March 25, 1997

SUBJECT: SUMMARY OF AP600 DESIGN REVIEW MEETING REGARDING THE PASSIVE CONTAINMENT COOLING SYSTEM (PCS) AND WGOTHIC COMPUTER CODE

Scaling Analysis for AP600 Containment Pressure
during Design Basis Accidents
WCAP-14845

Figure 1 Buoyancy Calculation for the AP600 PCS Air Flow Path Comparing Distributed and Thermal Center Approaches

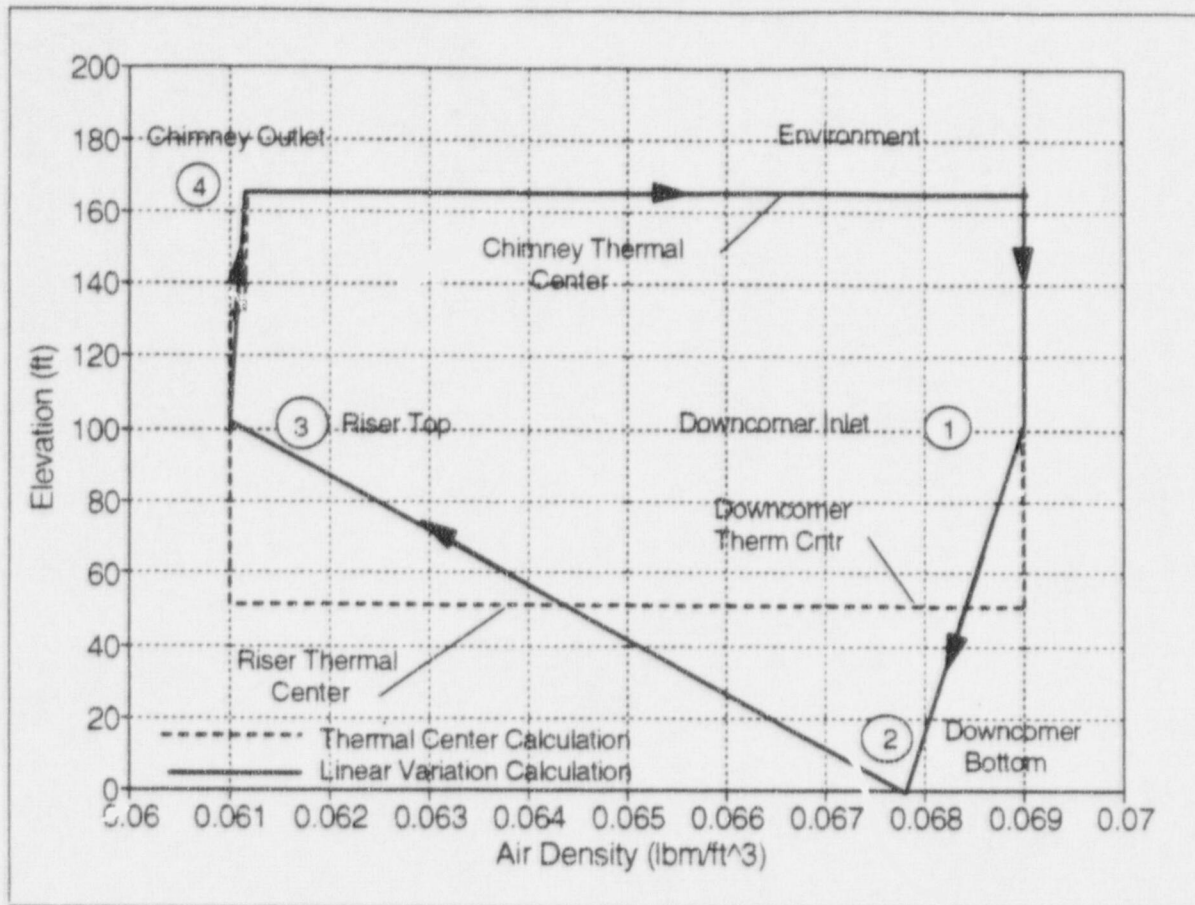
28. The buoyancy term (equation 102) is stated to be in terms of "thermal center"

differences. It is difficult to tell from Figure 8, just how H1, H2, H3 and H4 are defined. However, the densities, ρ_{dc} , ρ_{ri} , ρ_{ch} and ρ_{nv} are calculated based upon exit temperatures. If H2 - H3 is the riser height, then using a density based upon exit temperature will overestimate the buoyancy force by about a factor of about 2, since the average density should be used. Please explain how your approach accounts for the variation in density along each segment of the flowpath.

28. Figure 9-1 of WCAP-14845 clarifies the location of thermal centers. The discussion in Section 9.3.1 and Figure 9-2 show how the thermal centers are used with the density to calculate the buoyancy. The example calculation in WCAP-14845 is repeated below.

Figure 1 shows an example of a simplified PCS buoyancy calculation using density values calculated for the beginning of the long term time phase of the LOCA. The density variations over each leg of the air flow path are assumed to be linear. The net buoyancy is represented by the enclosed area. The buoyancy calculated using the thermal center approach is shown for comparison. For this case both the distributed density and thermal center approaches give the same result. Note that for this assumed case, the net buoyancy is not affected by the amount of heat transferred from the riser to the downcomer. (Moving point 2 along the horizontal axis does not change the area within triangle 1-2-3). However, moving point 2 does change the relative ratio of negative downcomer buoyancy to positive riser buoyancy. Moving the thermal centers of the downcomer and riser up to the 84 ft elevation, as was done for the AP600 scaling calculation, significantly reduces the net buoyancy.
